City of Richmond
Planning and Development Department

Report to Committee

To: Planning Committee
From: Jean Lamontagne
Director of Development
Date: November 2, 2006
File: RZ 05-296591
Re: **Application by H.A. Berg Investments Ltd. for Rezoning at 11991 No. 1 Road and 3931 Chatham Street from Service Station District (G2) to Steveston Commercial (Three-Storey) District (C5)**

WEST ELEVATION

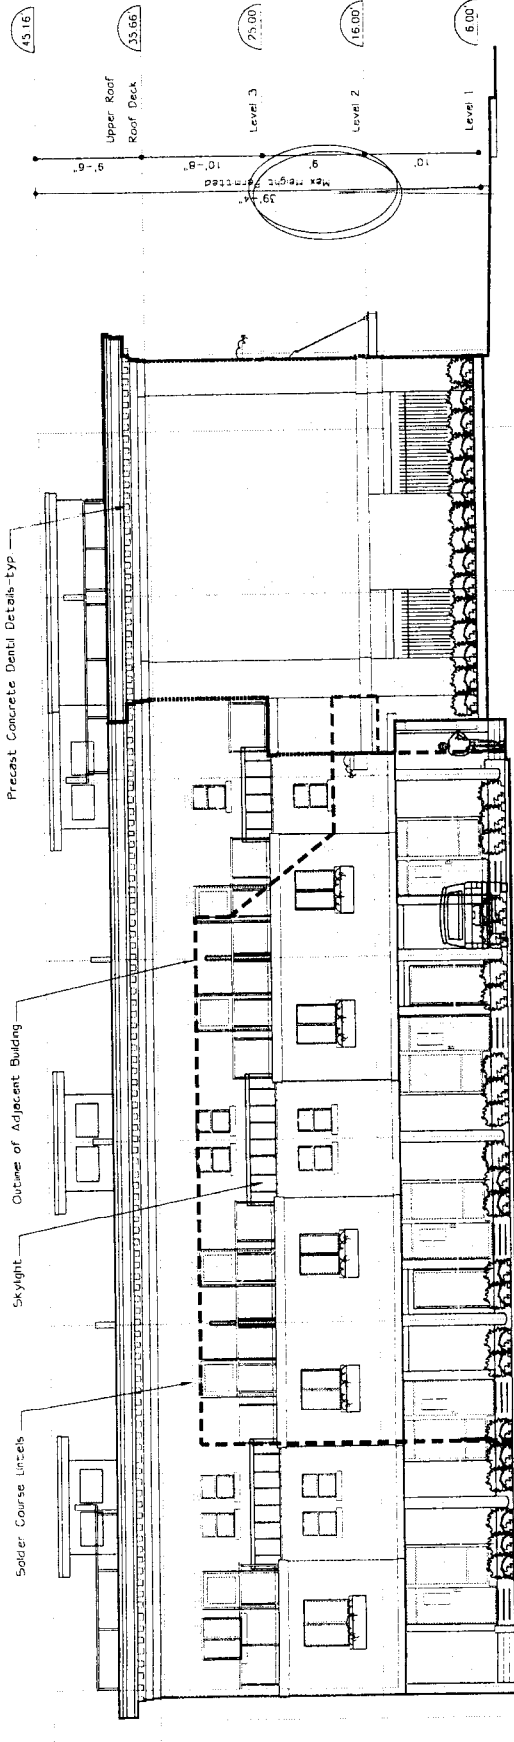
- The current design has incorporated windows on the west elevation. The building is built close to the property line, there might be limiting distance issues with respect to the amount of proposed openings.

EAST (NO. 1 ROAD) ELEVATION

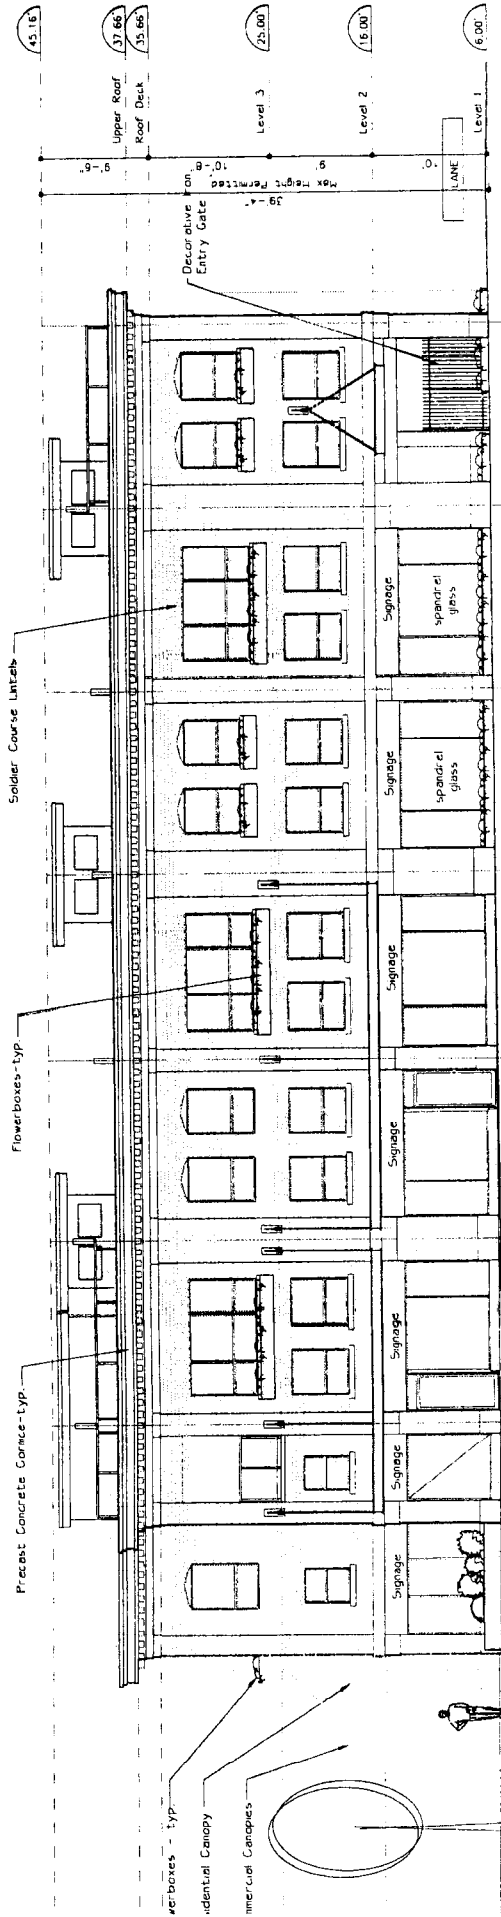
- The Heritage Commission recommended design development to the No. 1 Road façade at grade to provide continuous frontage including the mechanical and storage areas as part of the Development Application process.
